**TRANSWESTERN PIPELINE**  
An ENERGY TRANSFER Company

**RE: Response to Approval Letter Comments**  
2017 Annual Report  
Roswell Compressor Station No. 9  
Transwestern Pipeline Company  
Roswell, Chaves County, New Mexico  
NMOCD Case #GW-052  
EPA ID No. NMD986676955  
HWB-TWP-17-002

DRAWN: HVP CHECKED: RLA DATE: 03/18 FIGURE: 3-5

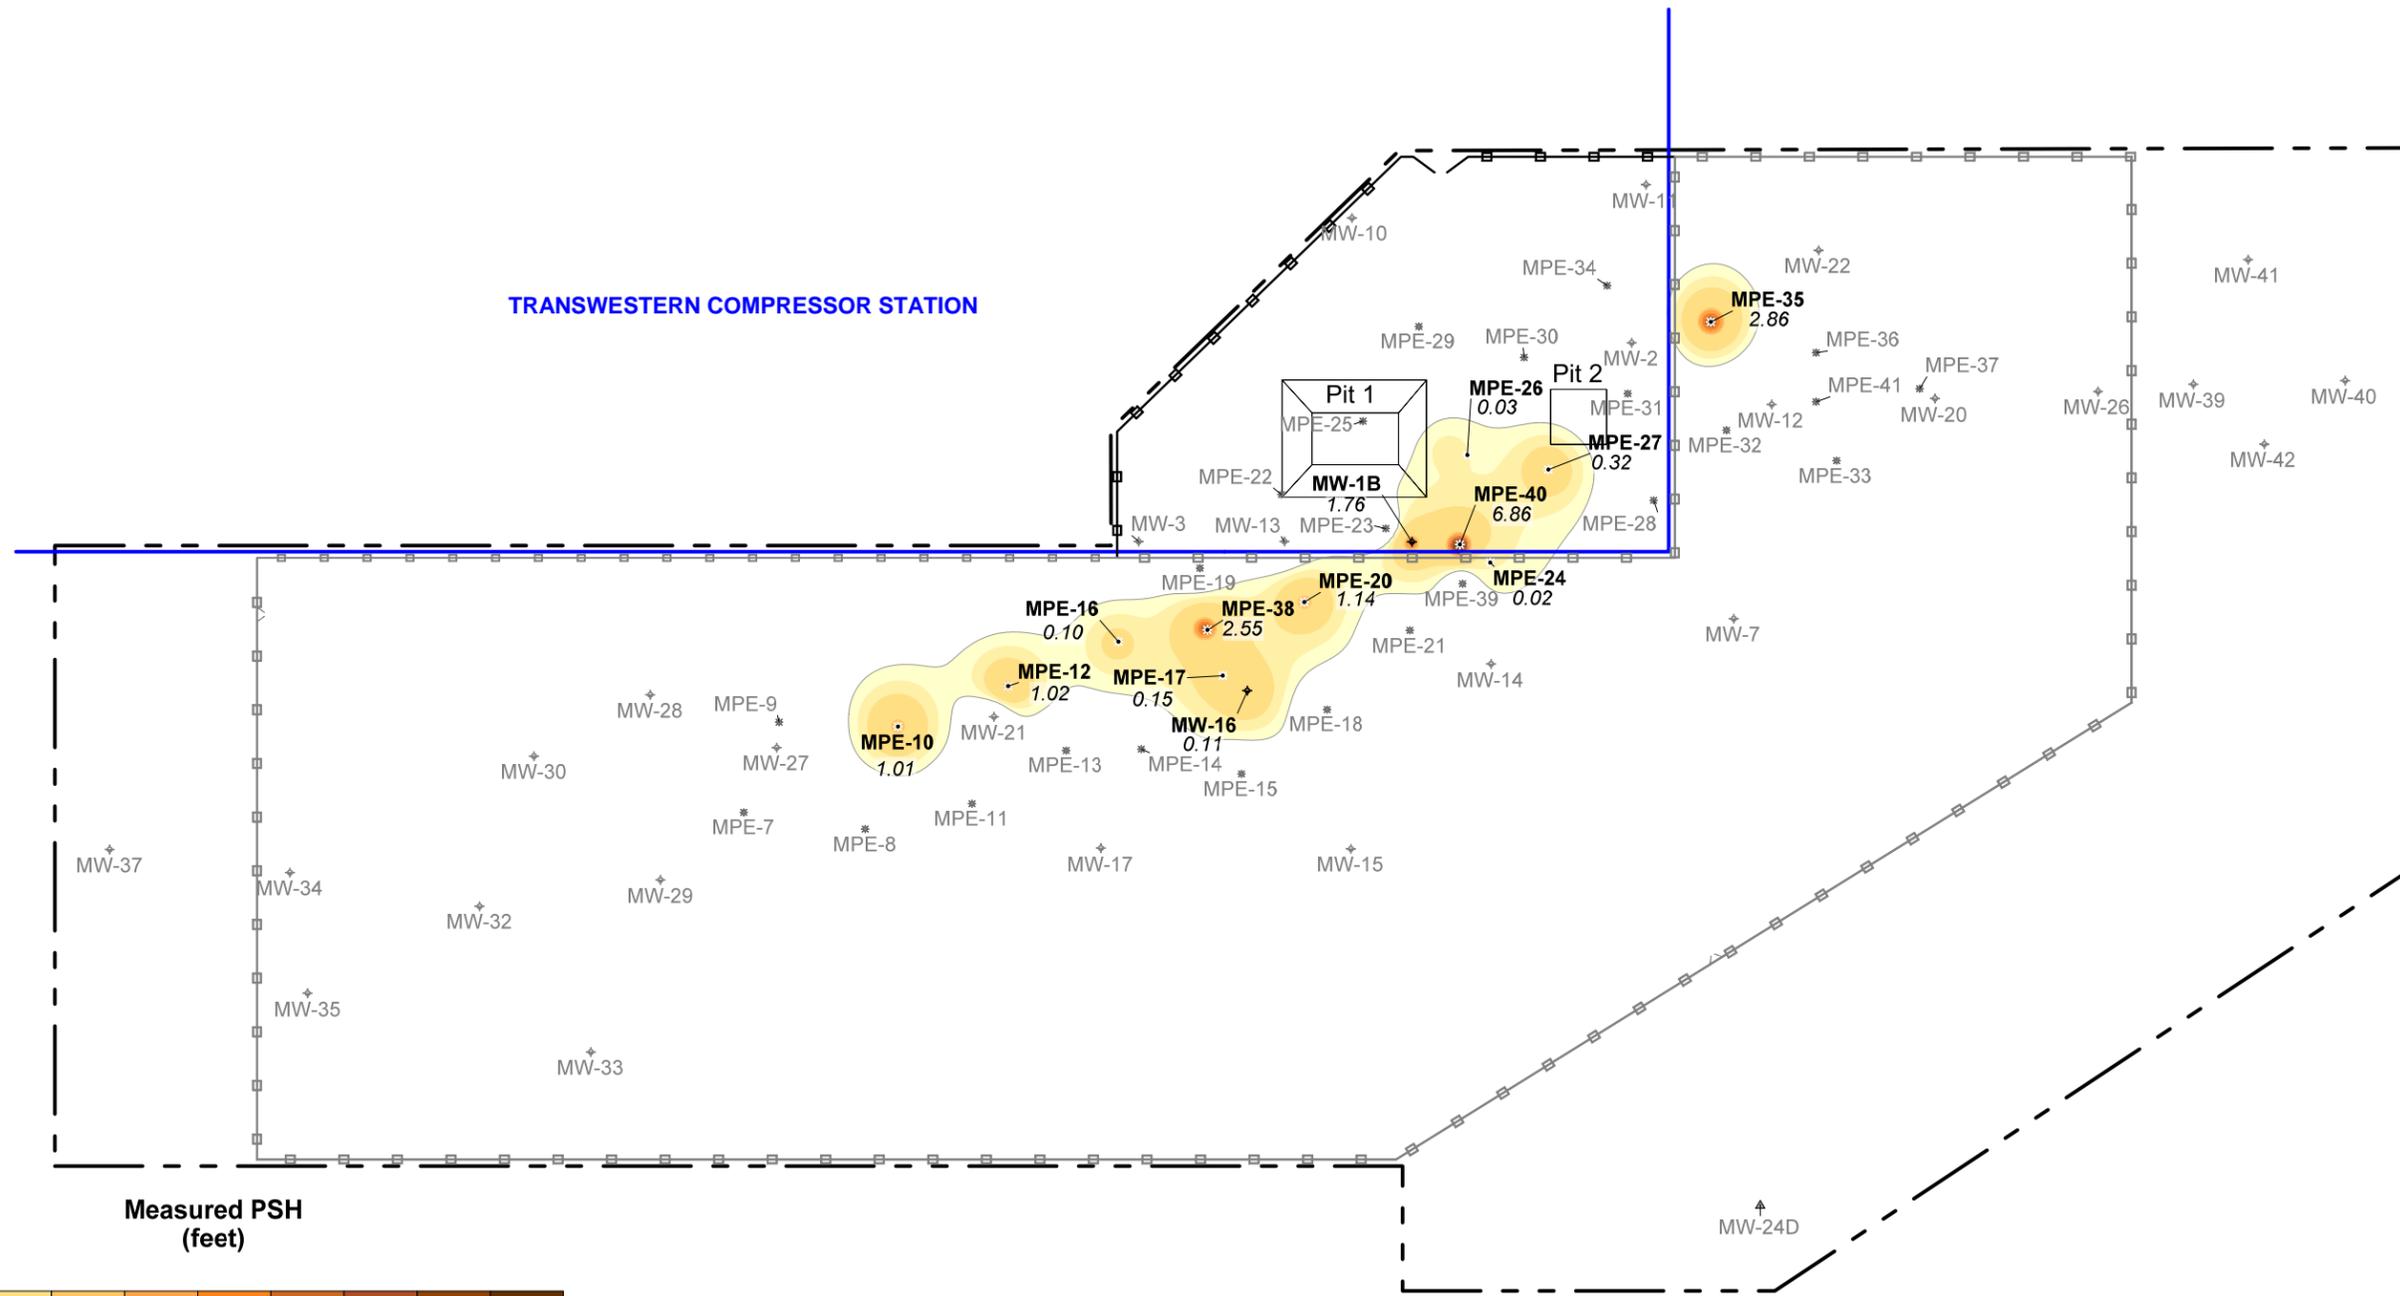
Figures 3-4 and 3-5 use color scale to depict a thickness contour for measured phase separated hydrocarbons (PSH). The thickness of PSH and the color that represents its thickness do not match in the figures. For example, the thickness of PSH in well MPE-10 is recorded as 0.90 feet in Figure 3-4; however, the color representing its thickness depicts more than one foot. The thickness of PSH in well MPE-10 is recorded as 1.01 feet in Figure 3-5; however, the color representing its thickness depicts less than one foot. Revise Figure 3-4 and Figure 3-5 to present accurate PSH thickness. Provide replacement pages for the figures in the response letter.

**Attachment C** contains the revised Figures 3-4 and 3-5.
